From: Wesley Patrick [wpatrick@cnwra.swri.edu]
Sent: Tuesday, January 16, 2007 1:54 PM
To: 'CNWRA_Dirs_Managers'; 'Goodluck Ofoegbu'; 'Luis Ibarra'; 'Chandrika Manepally'; 'Yi-ming Pan'; 'David Pickett'; 'Roberto Pabalan'; 'Osvaldo Pensado'; 'Ron Janetzke'; jmancillas@cnwra.swri.edu; 'Hakan Basagaoglu'; [REDACTED]
Subject: RE: TPA Code Modifications: Drift Degradation
Attachments: Drift Degradation (125 KB)

Determining Inventory Available for Release from Waste Packages Failed by Localized Corrosion

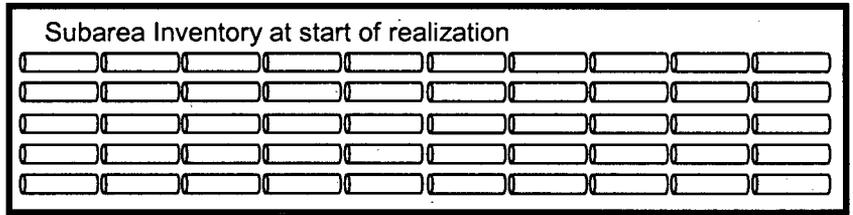
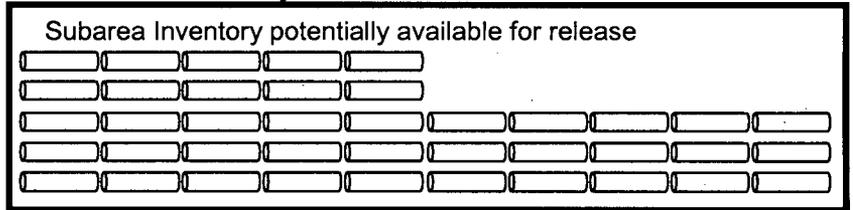
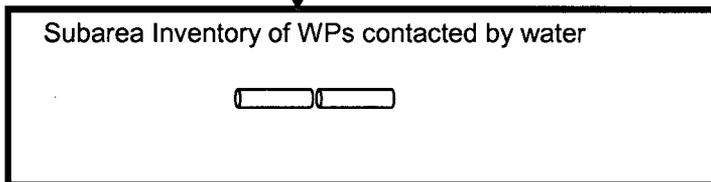
1. The graphic addresses just the water release path for radionuclides. Direct release (via extrusive igneous activity) and gaseous release are considered separately. Suggest revising the title to state this explicitly:
"...Available for Water-Borne Release..."

2. The annotation on the upper left side of the graphic indicates a calculation that is made for "all" failure modes. In addition to the clarification noted in Item 1, suggest listing in parentheses the failure modes that are considered in TPA for water-borne release. My understanding is that these are (i) initial defect, (ii) subsequent mechanical breach, (iii) localized corrosion (e.g., pitting, crevice, SCC), (iv) general corrosion, and (v) effects of intrusive igneous activity.

3. At least part of the discussion and lack of agreement to date seems to be based on the perspective of the individuals involved. The TPA code, as evidenced in the graphic, takes what might be called a "process-based" approach: water is the starting point because without water, water-borne release is literally impossible. Many of the engineers, however, take what might be called a "failure-based" approach: a defect, rock fall, offset drip shield, etc. is the starting point. Neither is wrong, but an explanation and common understanding are needed to facilitate the dialogue.

4. The graphic does not make clear how time enters into consideration. Although the fourth text block on the left states that water contact "has to occur early, while the packages are hot," it is not at all clear where this comes into play. For example, is it handled by the code checking the temperature, checking the time, or manipulating the probability of wetting to some "effective value" that is different from what is shown. Explanation and annotation on the graphic are needed, in my view.

5. It may also be helpful to provide at least one other figure like this (i.e., for a different failure mode involving water-borne release). Doing so will help (i) illustrate parallels between how the two failure modes are treated (a concern raised in discussions last week was that LC was being treated differently) and (ii) communicate that TPA covers the various failure modes comprehensively.
